RS-00-132

Subject: Response to Request for Additional Information Regarding the License  
Amendment Request to Permit Up-rated Power Operations at Byron and  
Braidwood Stations

### **Response to Request for Additional Information Regarding a License Amendment Request to Permit Uprated Power Operations at Byron and Braidwood Stations**

Figure A.3-1  
EQ Profile Unit 1

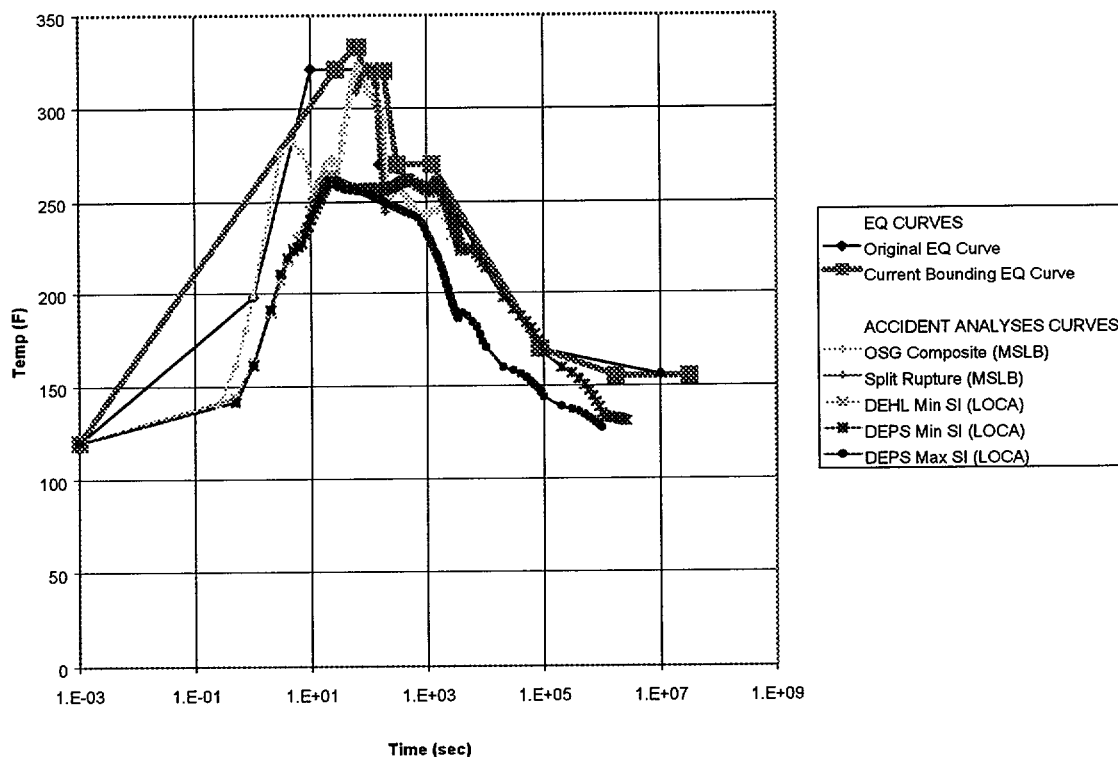
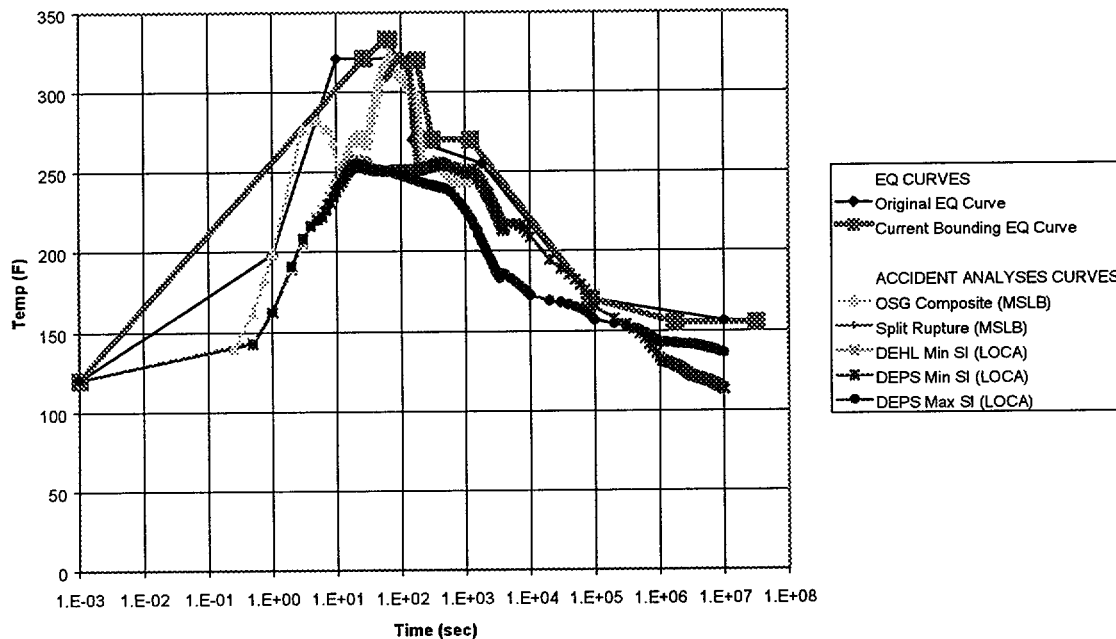
- A.3 *Explain, in detail, the bounding conditions of the containment revised temperature/pressure profiles as shown in Figures 9.3.21-1 and 9.3.21-2.*

The bounding conditions presented in Licensing Report Figures 9.3.21-1 and 9.3.21-2 were developed based on the revised analyses performed in support of the Byron and Braidwood Stations Steam Generator Replacement Project. These analyses remain bounding for uprated power conditions.

The Environmental Qualification (EQ) profiles for Unit 1 of Byron and Braidwood Stations, and Unit 2 of Byron and Braidwood Stations are presented in Figures A.3-1 and A.3-2, respectively. The following curves are provided for each unit as noted in the legend of each figure.

- Original EQ Curve: This curve presents the temperature vs. time profile for the EQ envelope developed as part of the original EQ Design Basis.
- Bounding EQ Curve: This curve represents the temperature vs. time profile for the revised EQ envelope, as described above, was developed as part of the reanalyses for the Steam Generator Replacement Project, December 29, 1999.

Figure G.12-1  
Unit 1 Pressurizer/Rupture SG Pressure

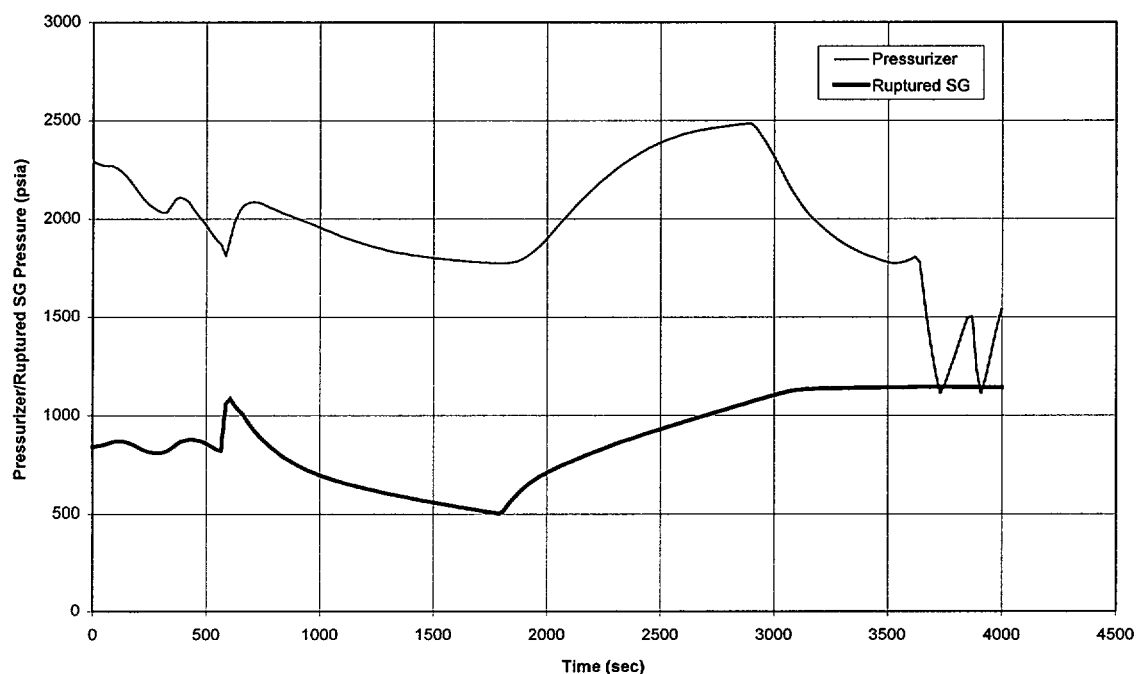
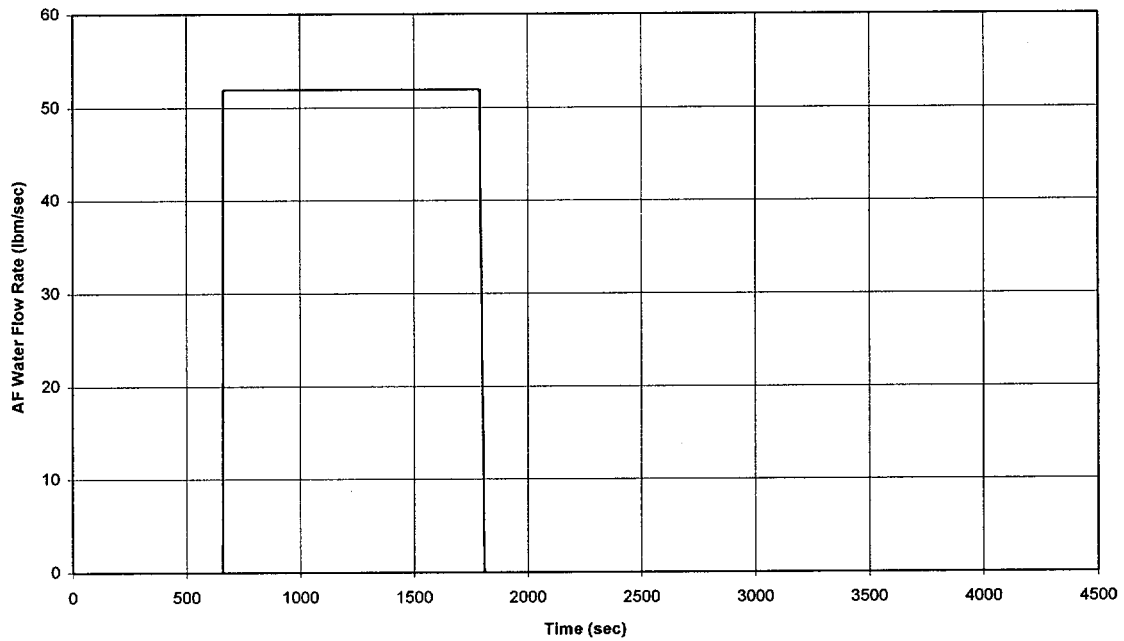
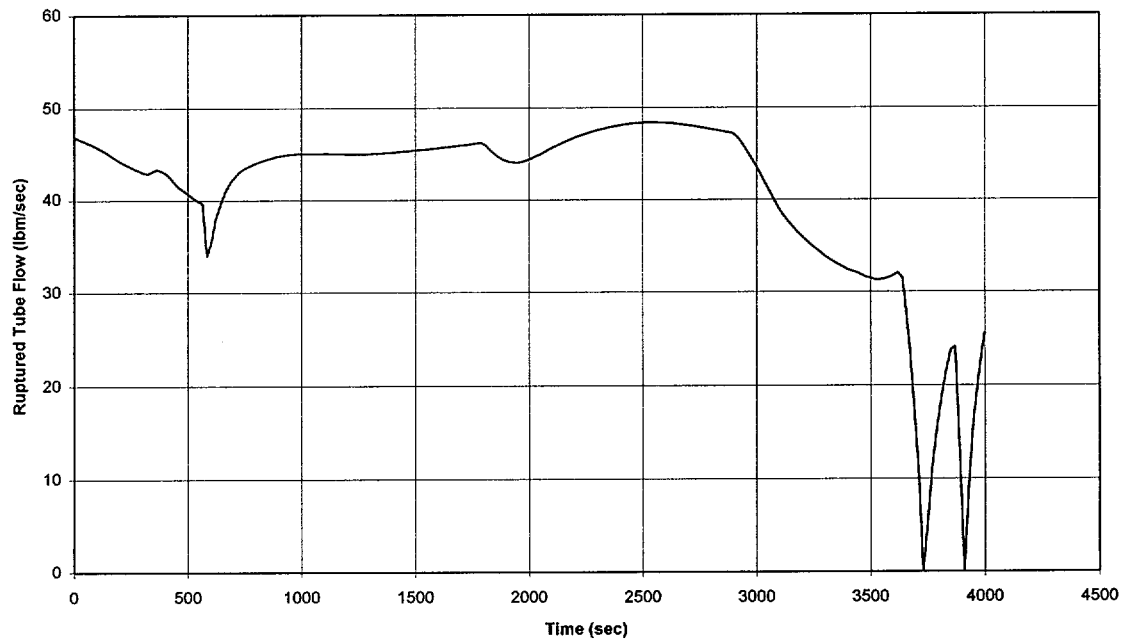
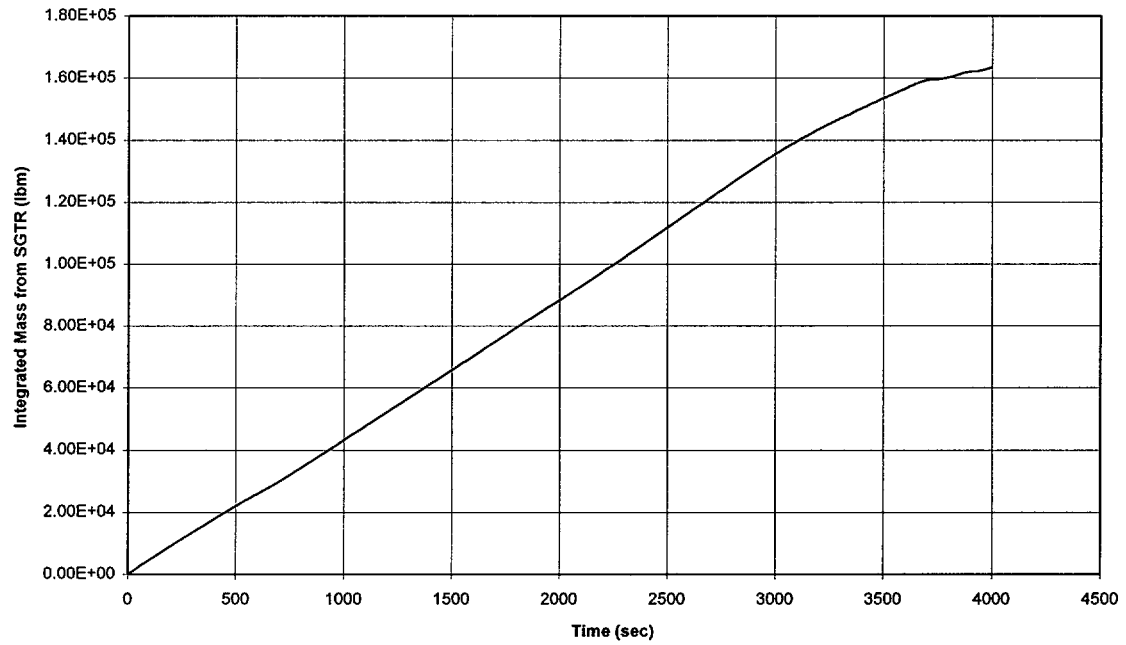
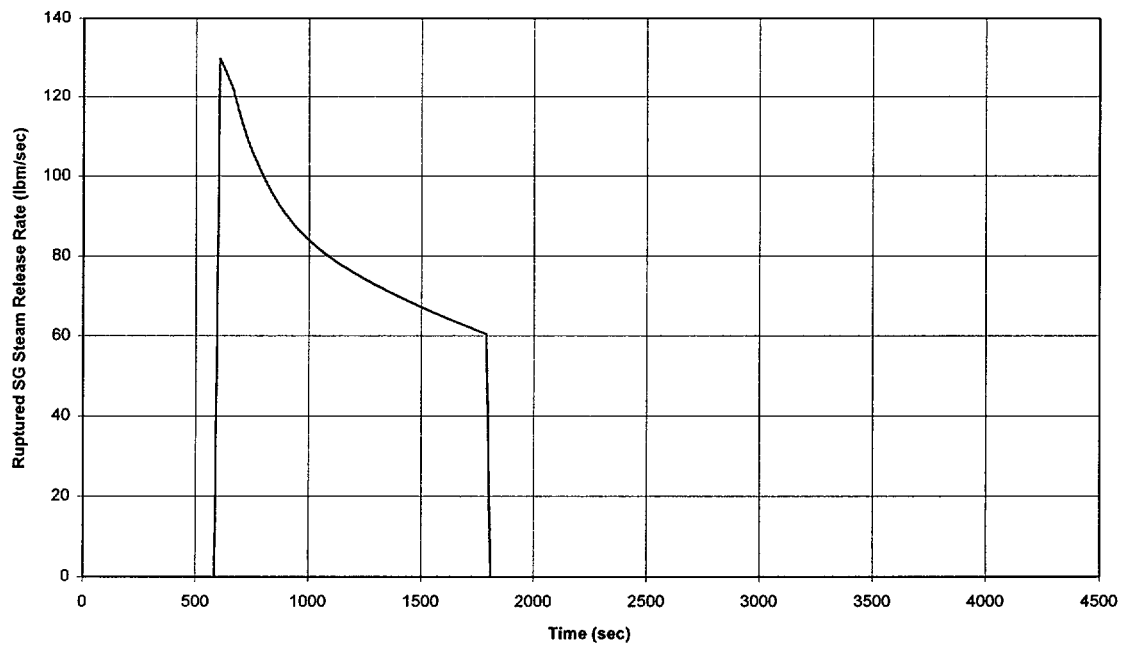
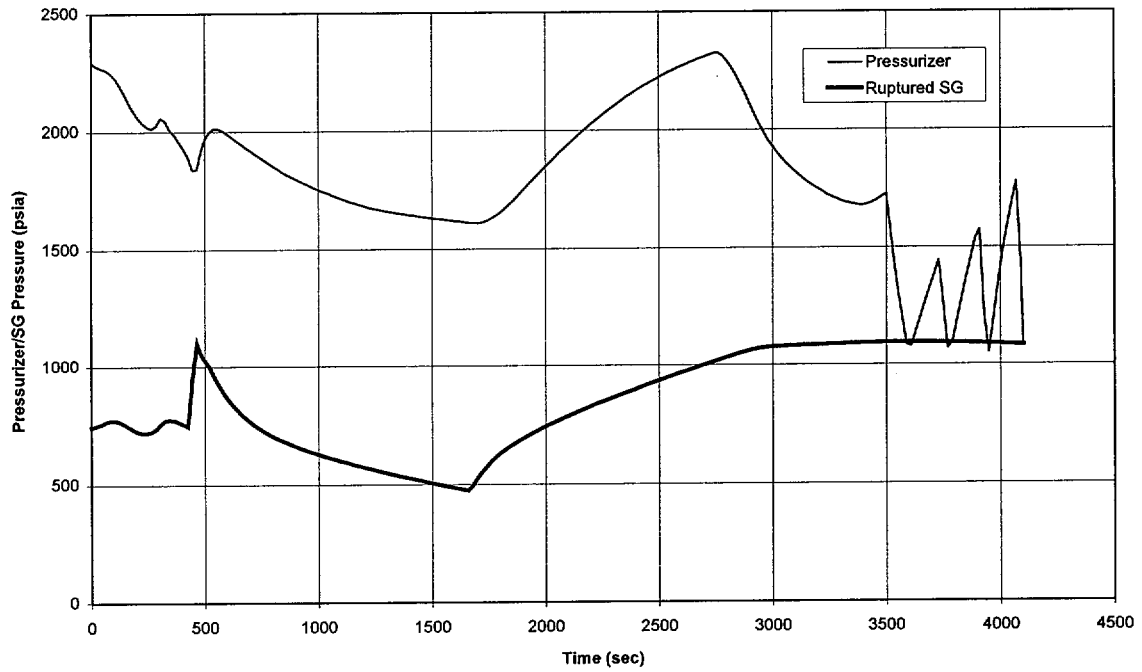
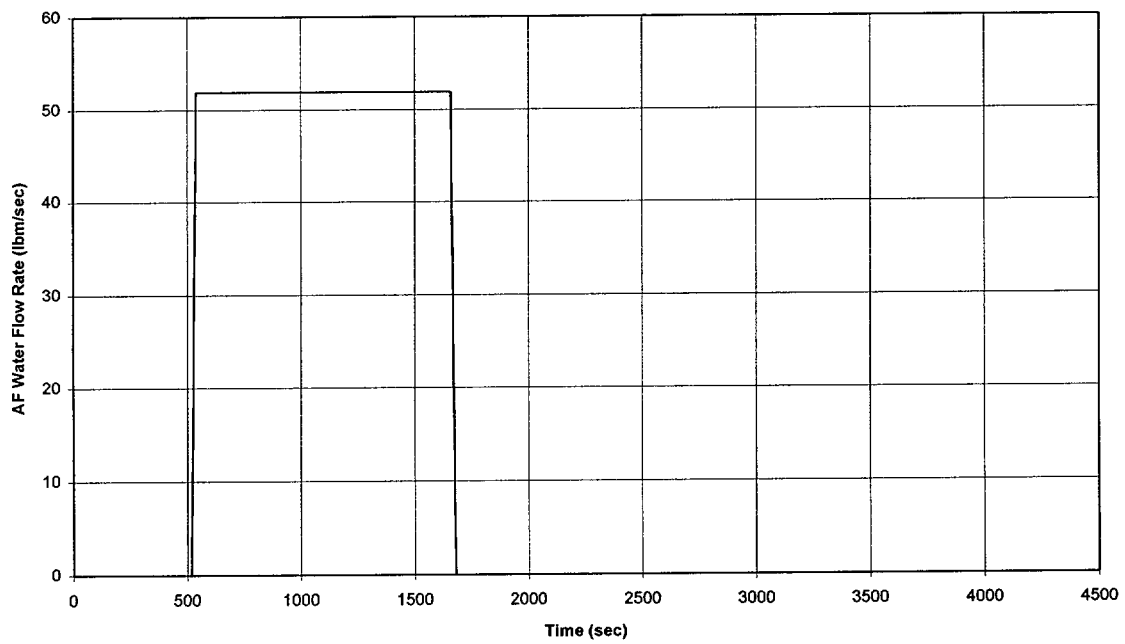
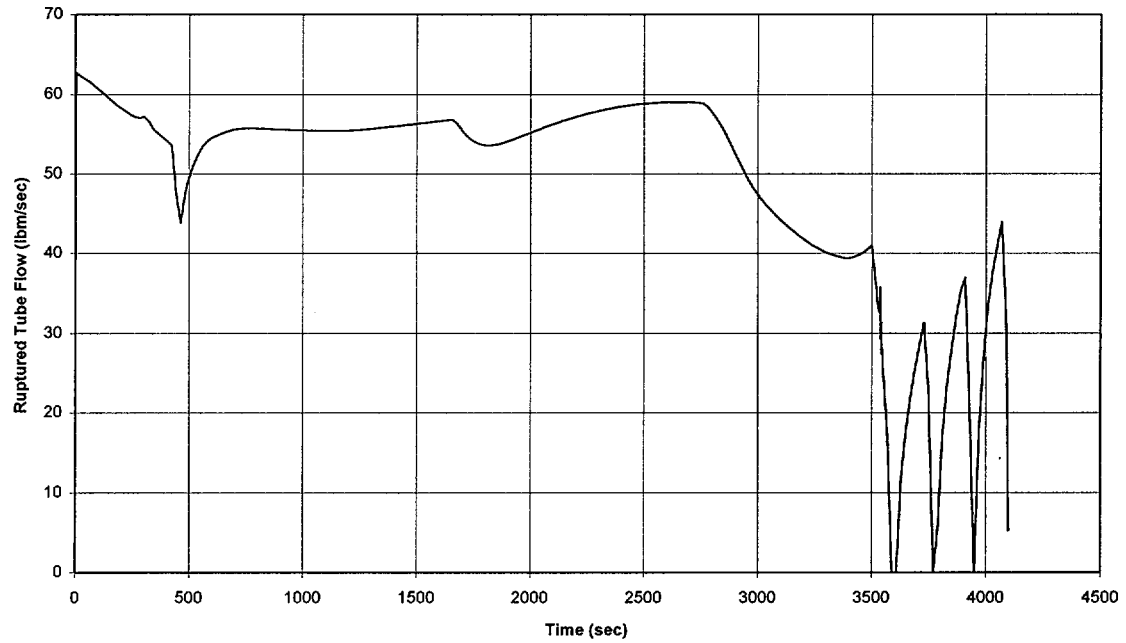
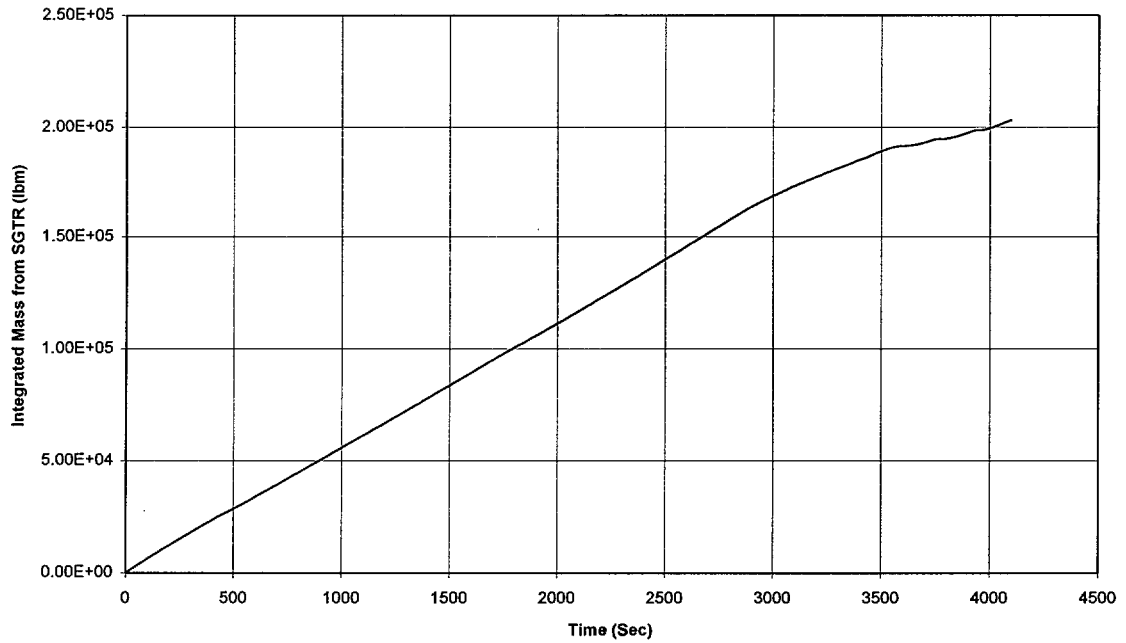
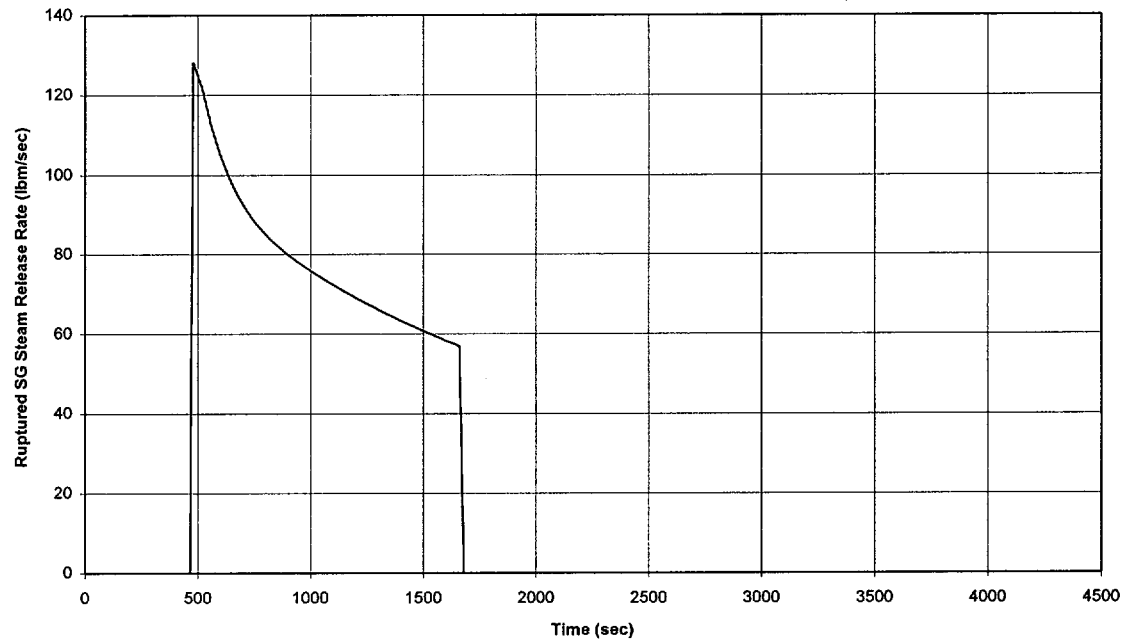
- G.12 *Please provide the results of a thermal hydraulic analysis for a SG tube rupture based on emergency operating procedures to determine the amount of radioactive steam released to the environment and assess the radiological consequences accordingly. In this analysis, a loss of offsite power should be assumed coincident with the steam generator tube rupture (SGTR) and a most limiting single failure of a stuck open SG power operated relief valve associated with the ruptured SG. Technical specification limit of tube leakage should be assumed as an initial condition. Transient curves including DNBR, RCS pressure, SG pressures, auxiliary feedwater flow, primary to secondary leak flow rate, integrated mass leaking from the primary to secondary side, steam release from the ruptured SGs, etc., should be provided.*

tube leakage. The SGTR event is bounded by the loss of flow event for DNB consideration. Section 6.2.11 of the Power Uprate Licensing Report presents the analysis for the loss of flow event and confirms that the minimum DNBR values are greater than the safety analysis limit. Consistent with approved SGTR methodology, explicit DNB analysis is not performed for the SGTR event.

Transient curves for RCS pressure, SG pressure, auxiliary feedwater flow, primary to secondary leak flow rate (ruptured tube flow), integrated mass leaking from the primary to secondary side (integrated mass from SGTR), steam release from the ruptured SG are presented in Figures G.12-1 through 5 for Unit 1. The transient curves for Unit 2 are presented in Figures G.12-6 through 10.
